GERALD R. FORD INTERNATIONAL AIRPORT

**TAXIWAY F & G RECONSTRUCTION (NORTH OF TAXIWAY V, 1,950' X 35');
TAXIWAY F & G AIRFIELD LIGHTING REPLACEMENT**

PROJECT NUMBER C-435

ADDENDUM #2

A1 CONSTRUCTION SAFETY AND PHASING PLAN - WORK AREA 1A
 SCALE: 1" = 20'

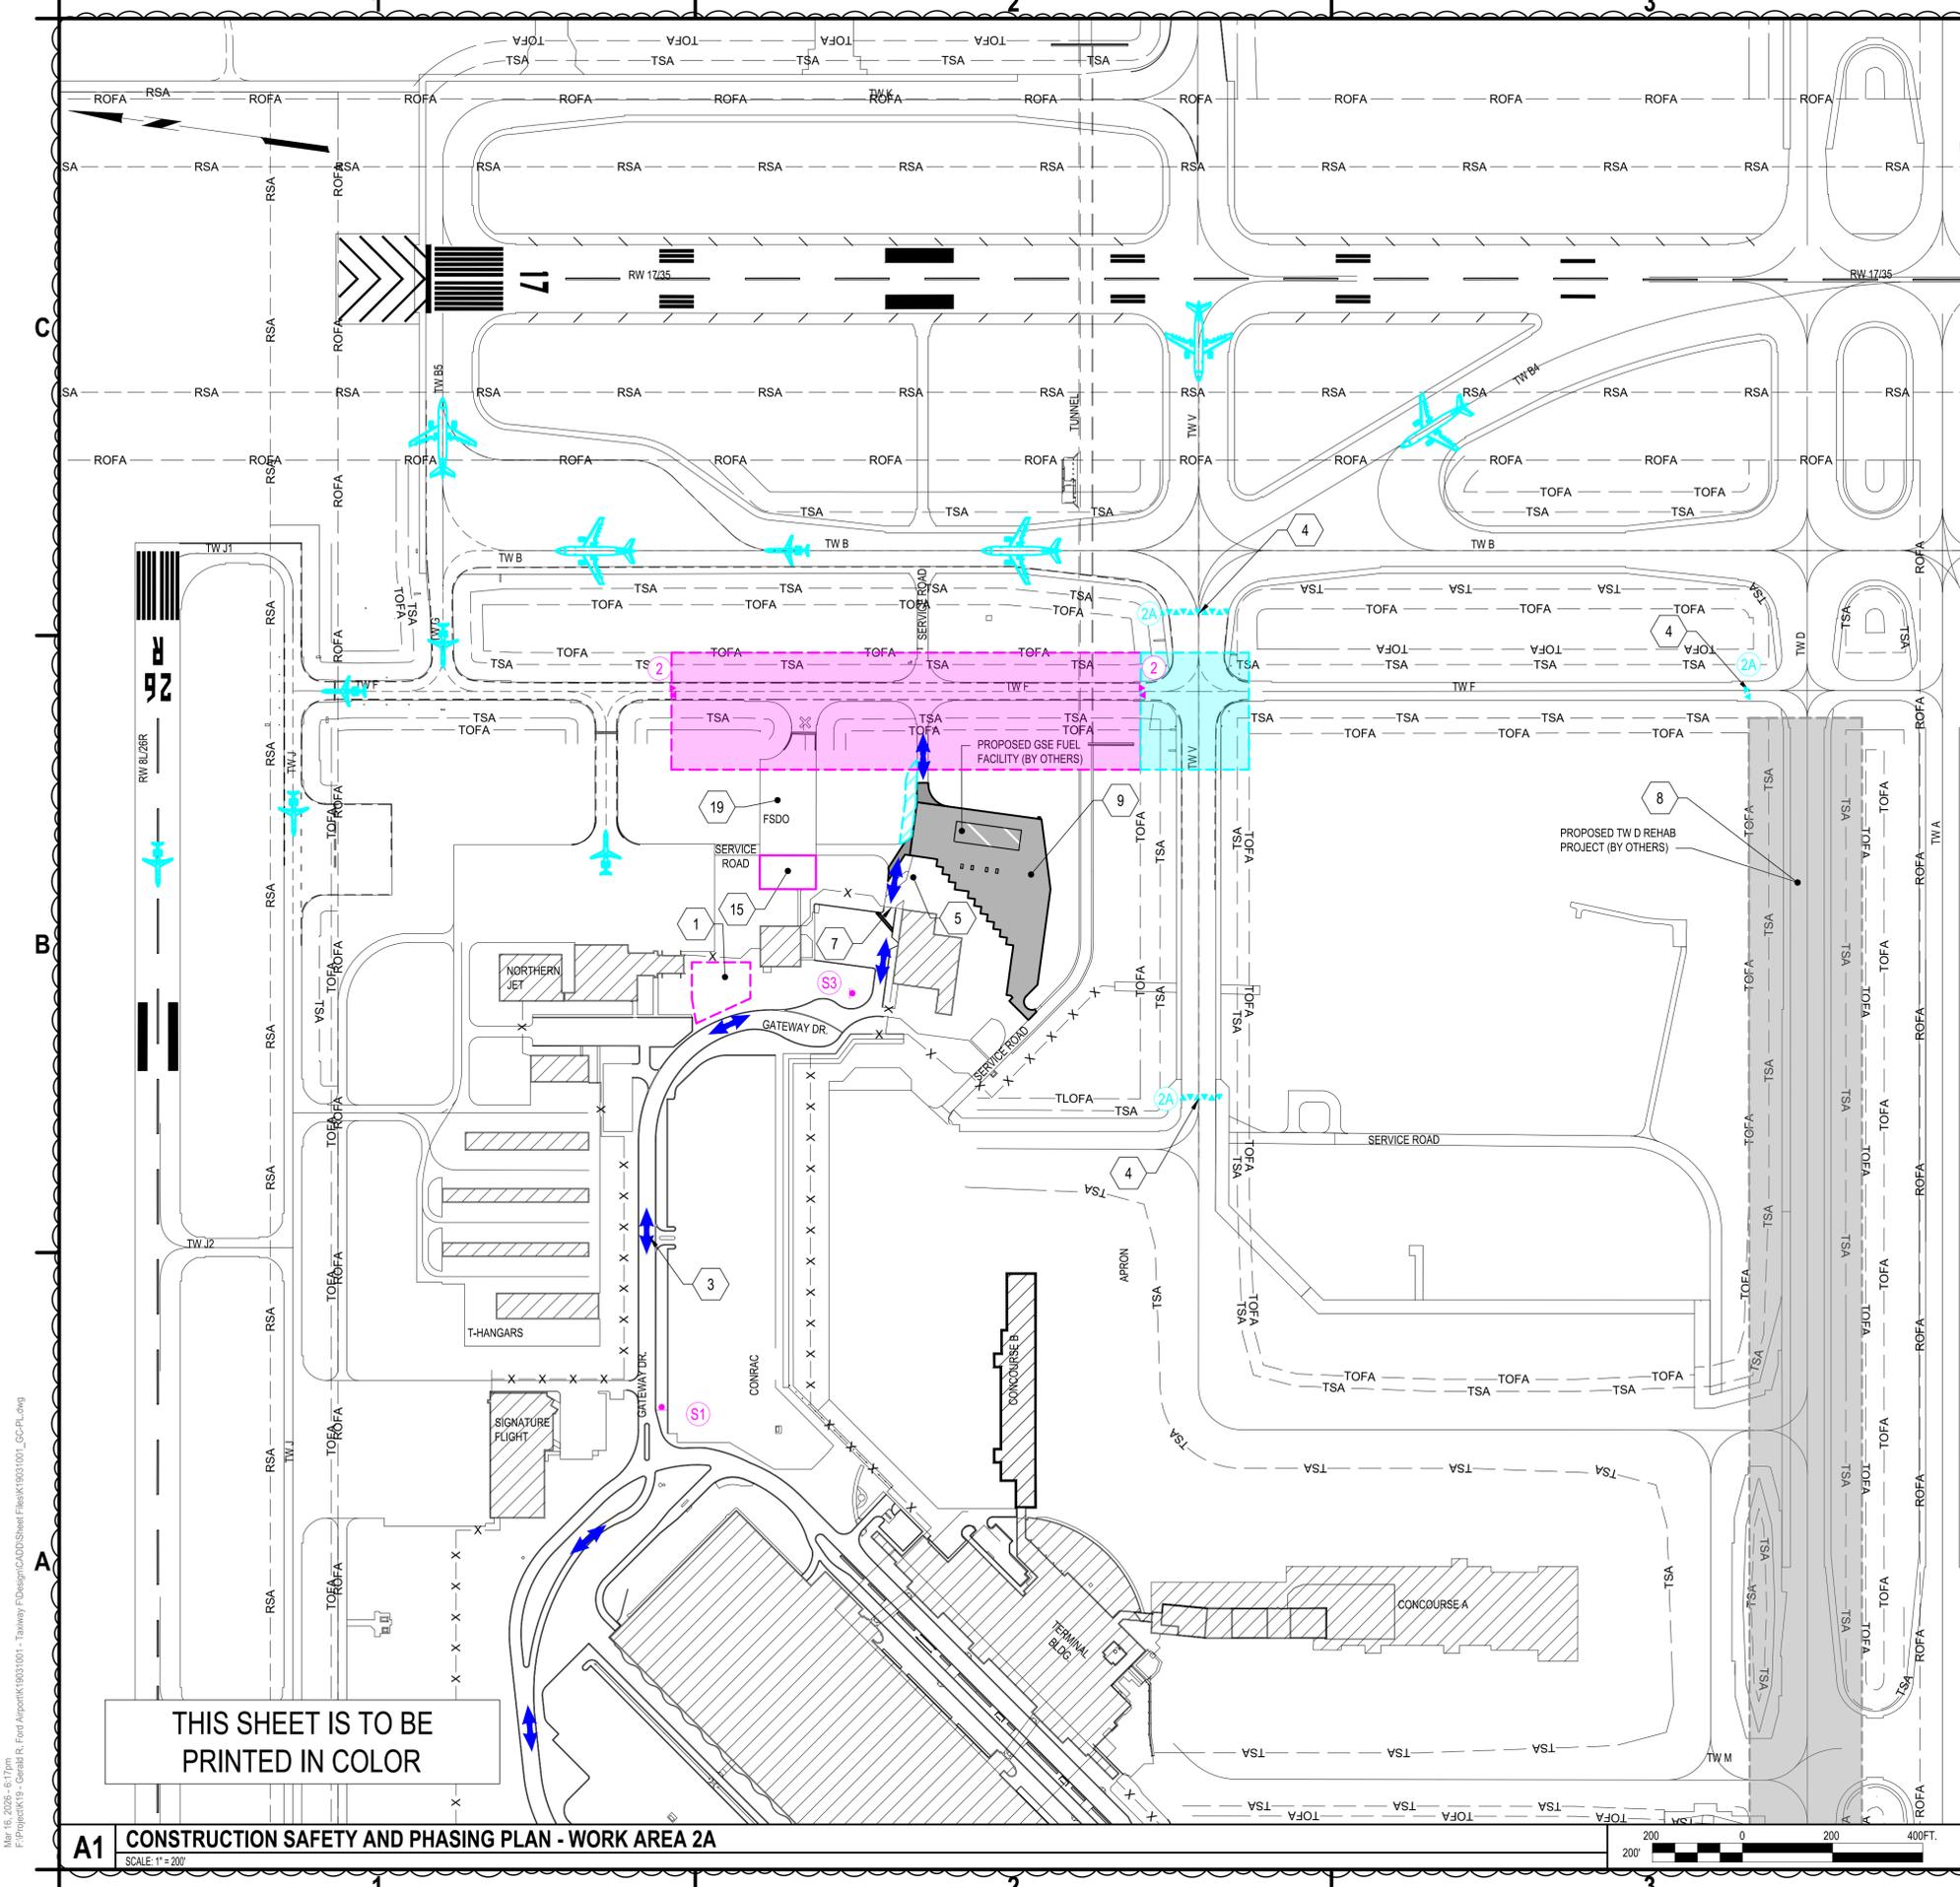
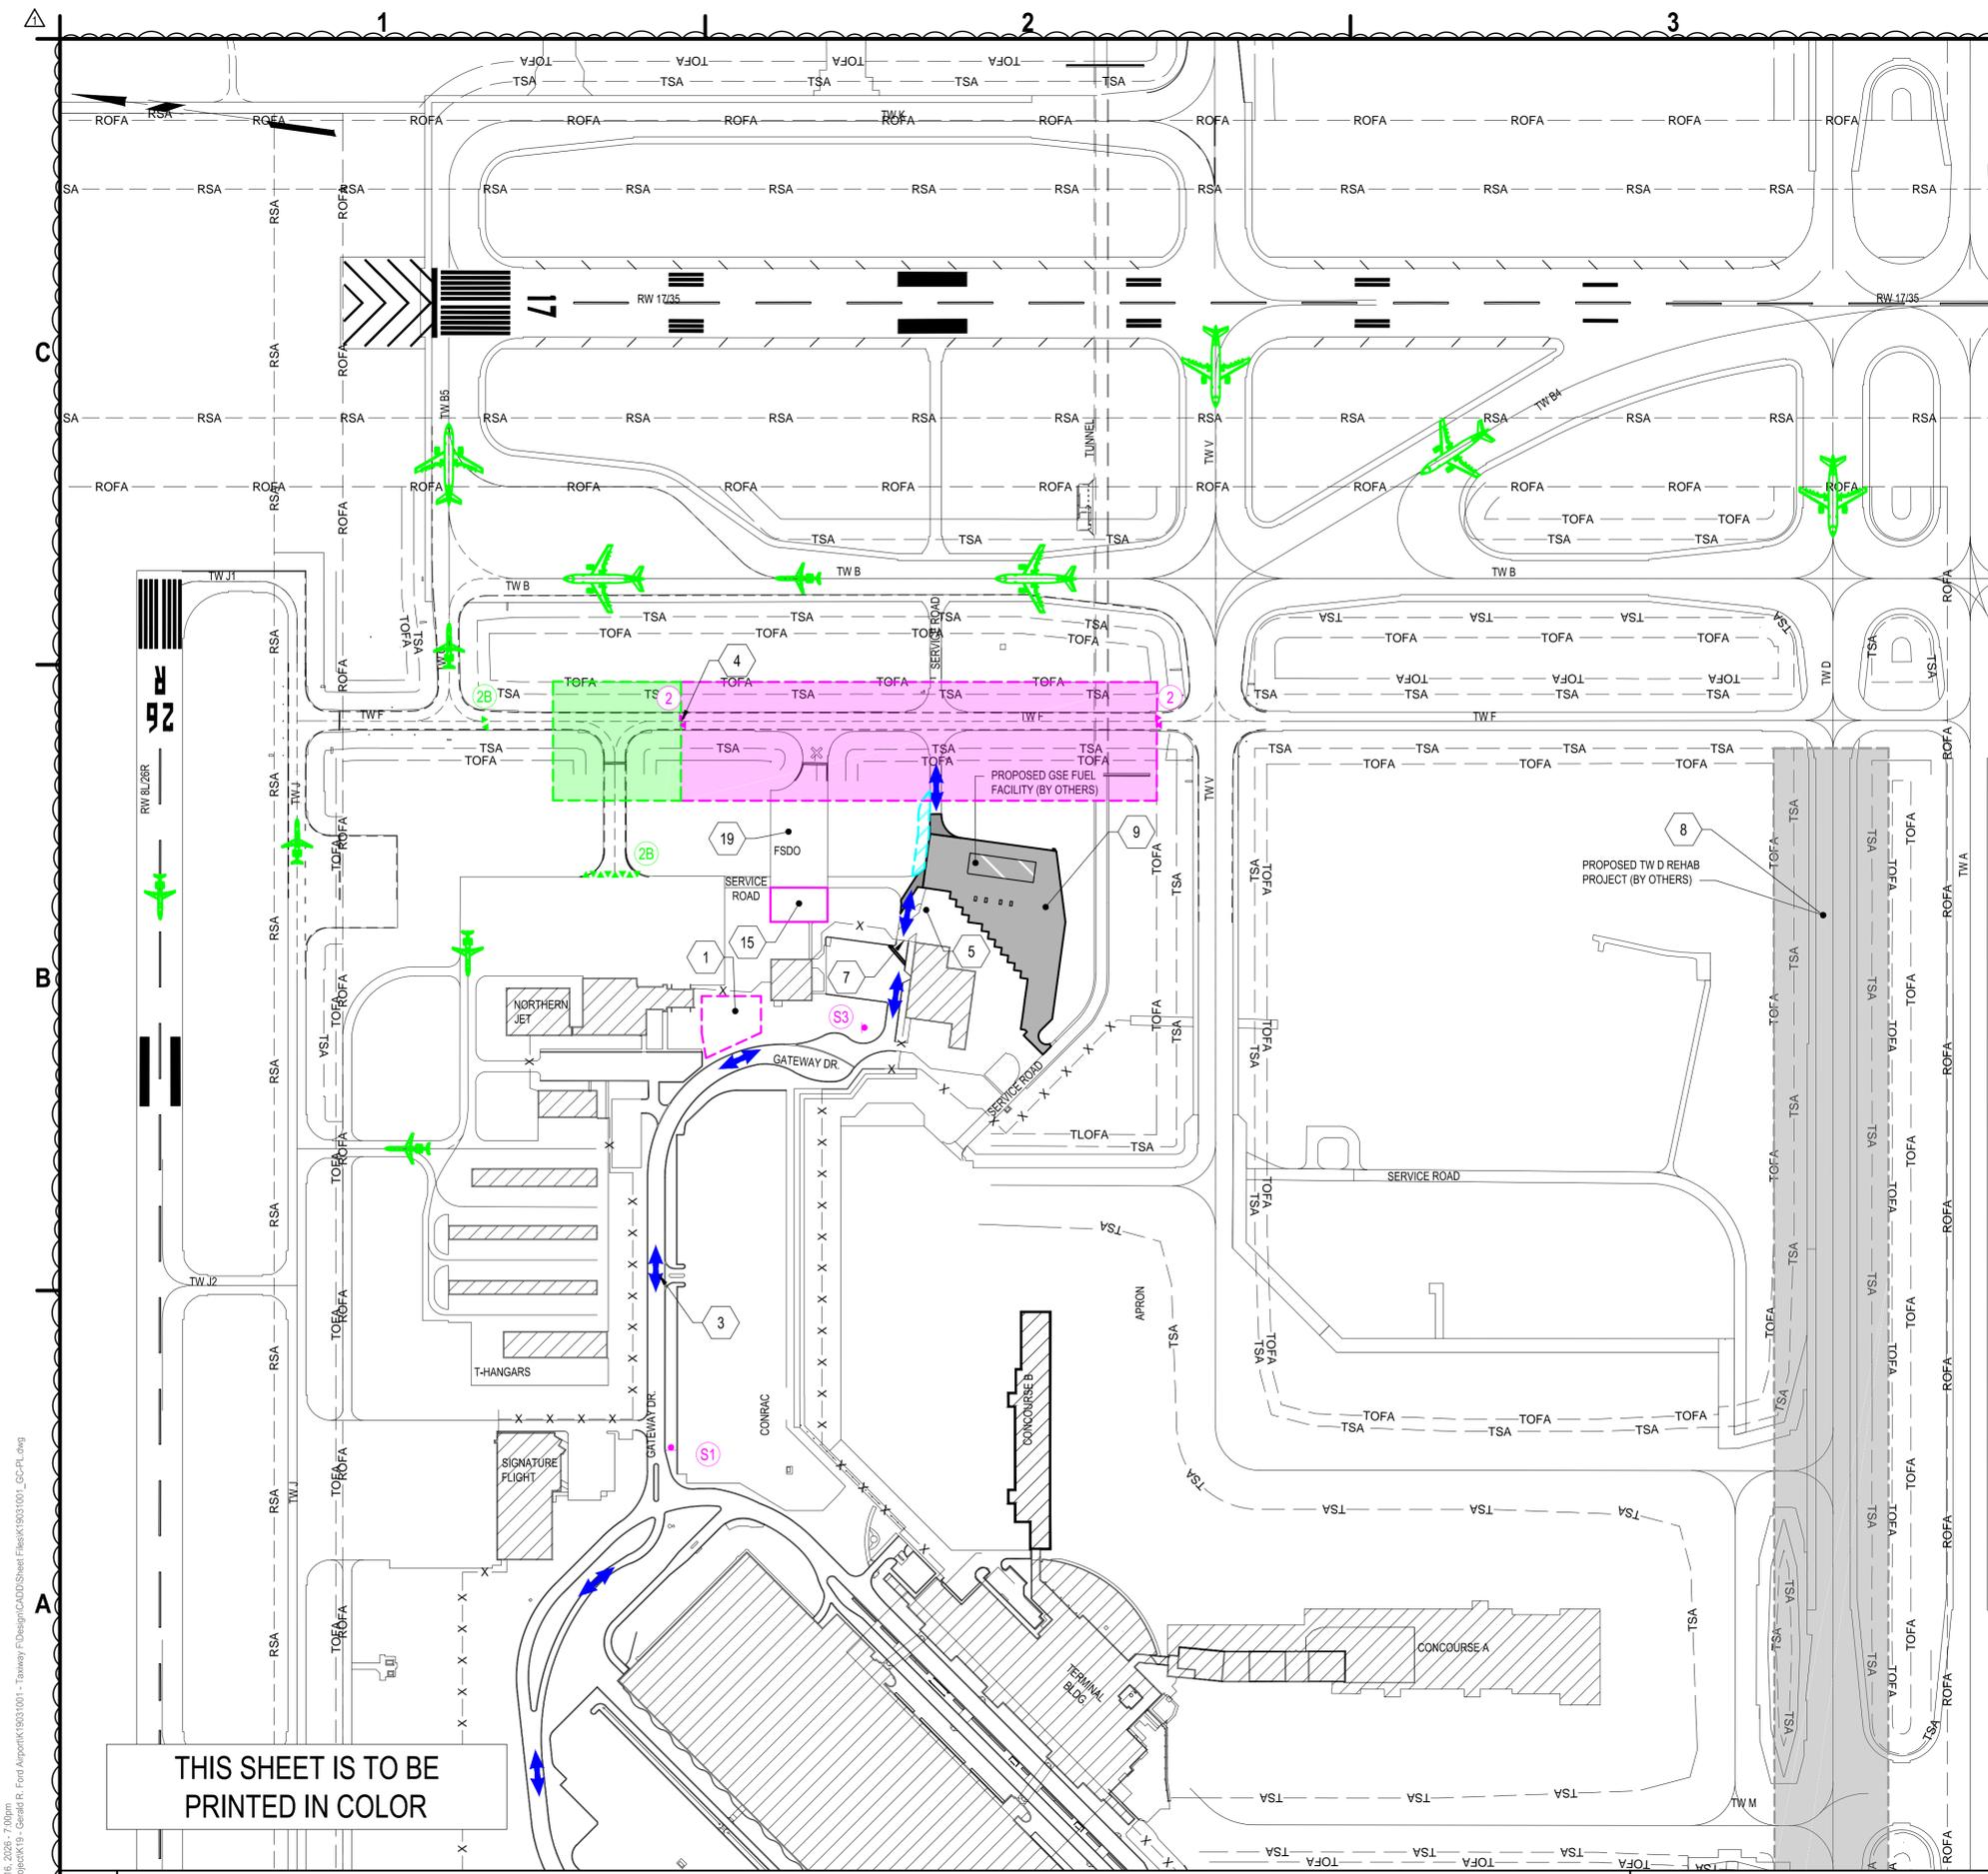
- Q: My main questions concern note no. 20 on pages GC102 thru GC105. The note states to “place low profile barricades in turf along TOFA”. Are these being interlocked for that area as well?
- A: The barricades to be used to line the TOFA in the turf along the gravel haul road may be spaced 10’ apart.
- Q: Sheet GC105: It has the note in the key notes but doesn’t show any no. 20’s (do you need barricades on the TOFA line on this page (which this one would actually be a much longer area along the TOFA – or don’t you need these because the haul road is no longer being utilized there)?
- A: No lining of the TOFA is needed in this phase. Keyed note 20 will be deleted from this sheet.

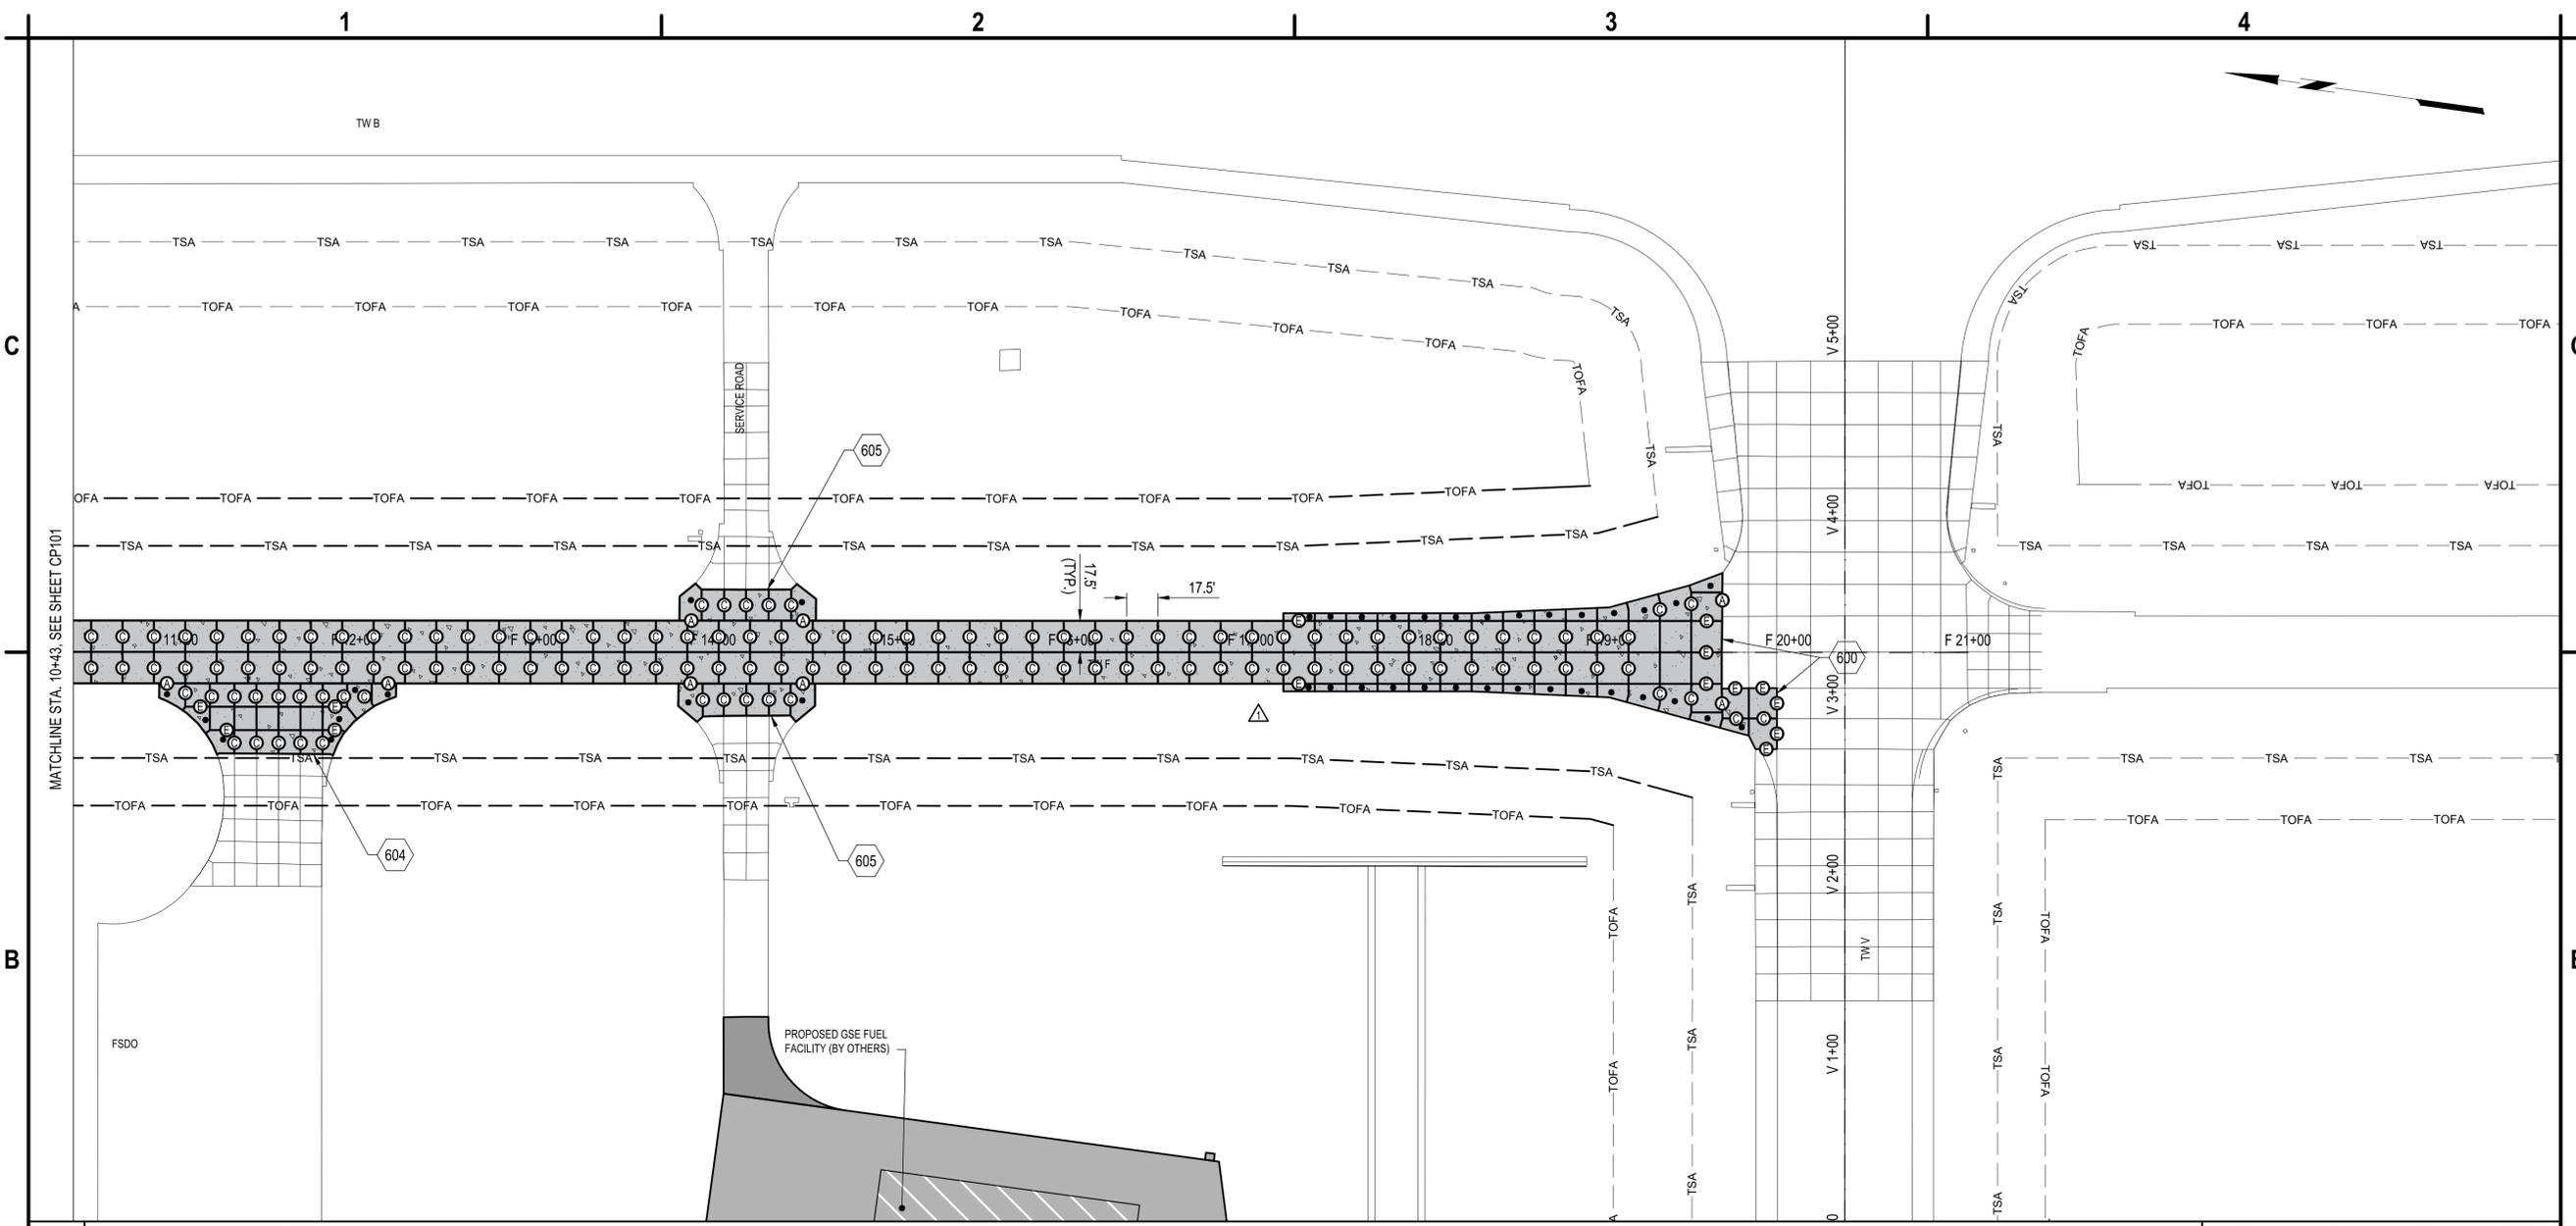
- Q: Could the Engineer consider an option for the concrete contractor to pour the two mainline 17.5ft lanes together eliminating the “E” construction joint with dowel bar and substituting a “C” contraction joint?
- A: Yes that will be allowed if the contractor elects to do so.
